Docket Item # 2
BAR CASE #2011-0103

BAR Meeting
June 1, 2011

ISSUE: Signage

LOCATION: 330 North Washington Street

Figure 3. Wall sign on North Washington Street elevation to be removed.

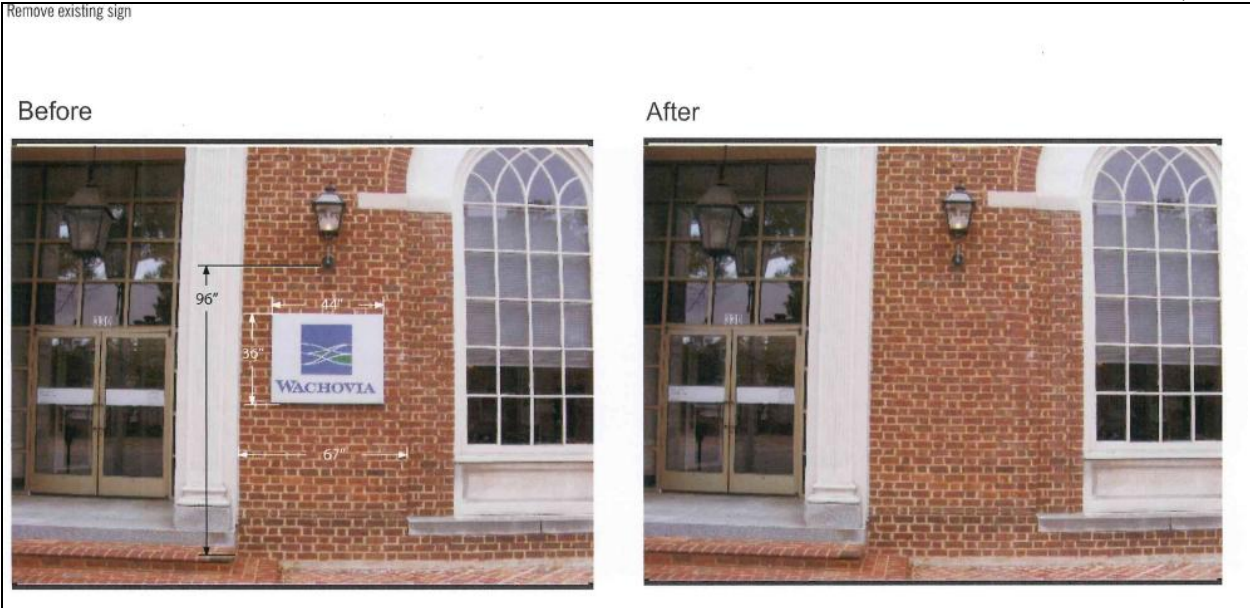
- The wall sign to the right of the front entrance (36"x44") will be removed and will not be replaced.
- Two wall signs attached to the drive-through teller piers will be removed and will not be replaced.

Figure 4. Hanging sign on North Washington Street elevation to be replaced.

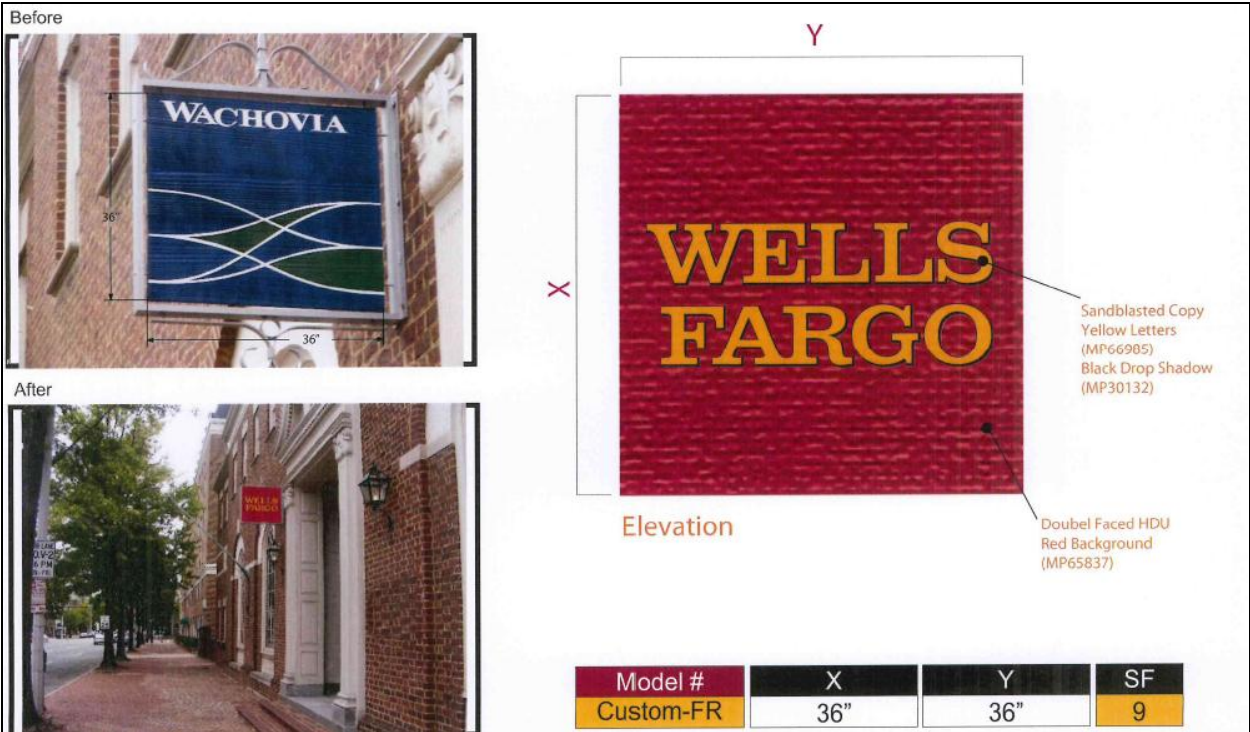
- The hanging sign (36"x36") to the left of the front entrance on North Washington Street will be replaced in kind. The existing scroll bracket will be reused. The new sign will be double-faced HDU with a yellow lettering on a red background.

Figure 7. Directional sign to be replaced.

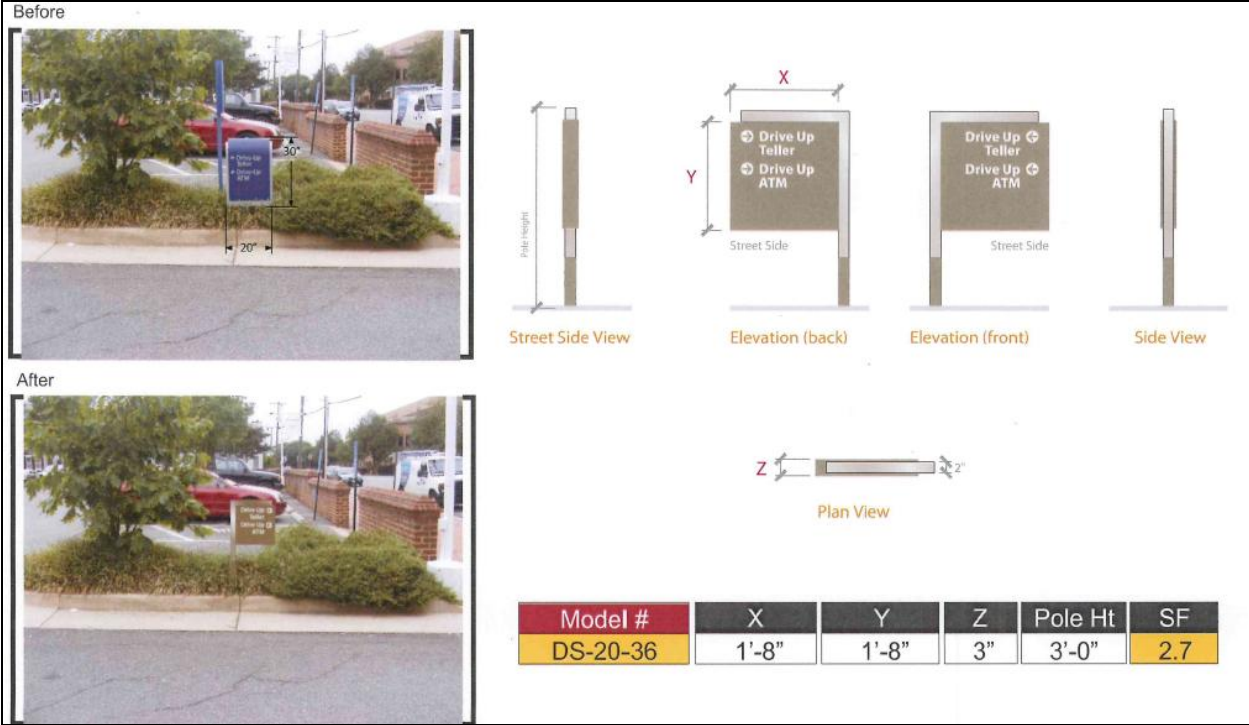
- A wall sign above the drive-through window will be replaced in kind ("Welcome to Wells Fargo" and measuring 12"x124").
- A directional sign on the property in a planting bed by the side entrance will be replaced and will be slightly smaller than the existing (existing: 20"x30" and proposed: 20"x20"). The sign will direct customers to the "Drive Up ATM" and "Drive Up Teller." It will be architectural aluminum with vinyl lettering.

Figure 8. Directional sign to be replaced.

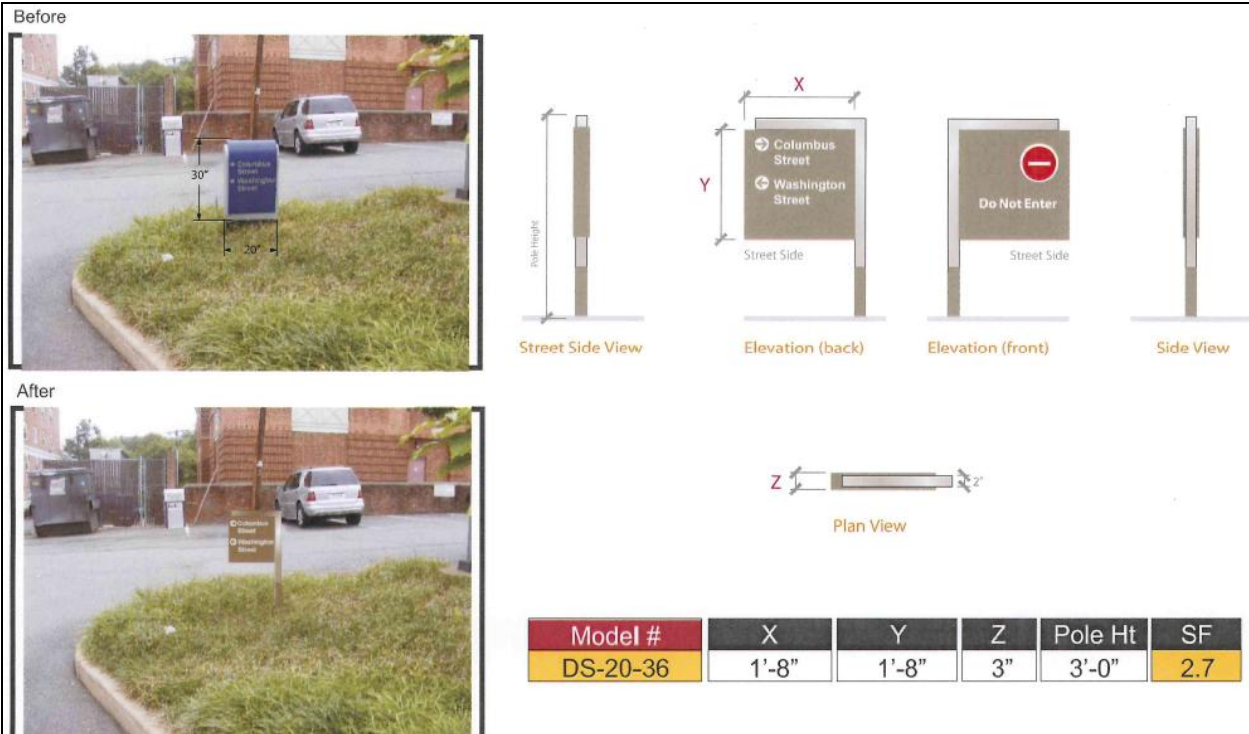
- A directional sign on the property in a planting bed in the parking lot will be slightly smaller than the existing (existing: 20"x30" and proposed: 20"x20"). The sign will direct customers to the "Columbus Street" and "Washington Street." It will be architectural aluminum with vinyl lettering.

Figure 11. Informational sign at drive-through.

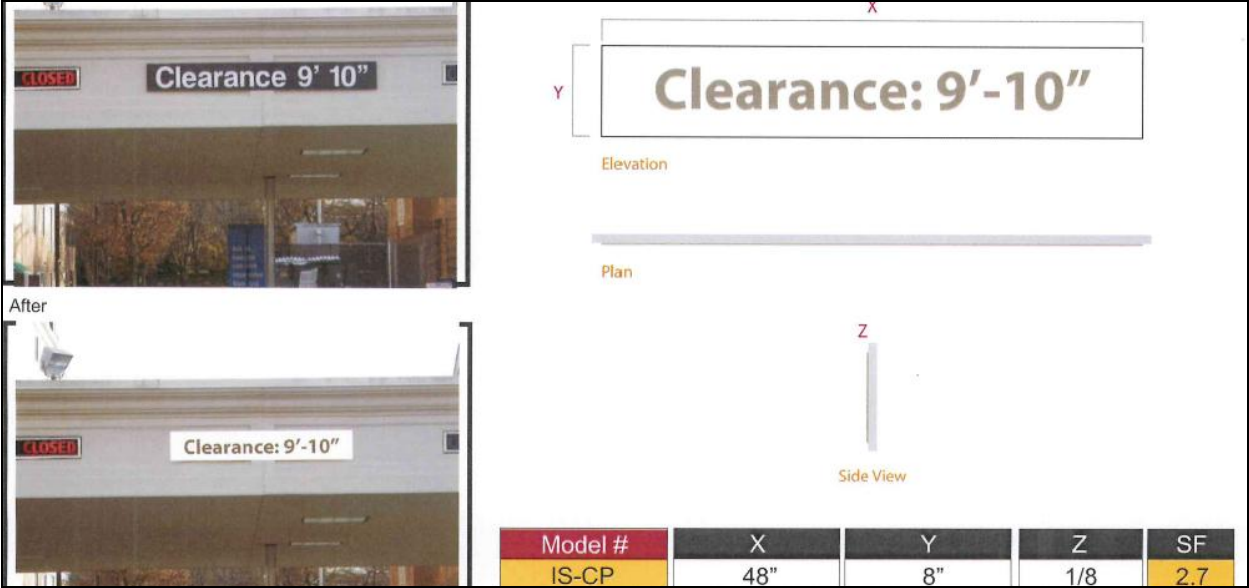
- An informational sign at the drive-through teller will be replaced in-kind ("Clearance: 9'10"" and measuring 48"x8").
- The two existing freestanding "Drive-In Window" signs on Princess Street will remain.
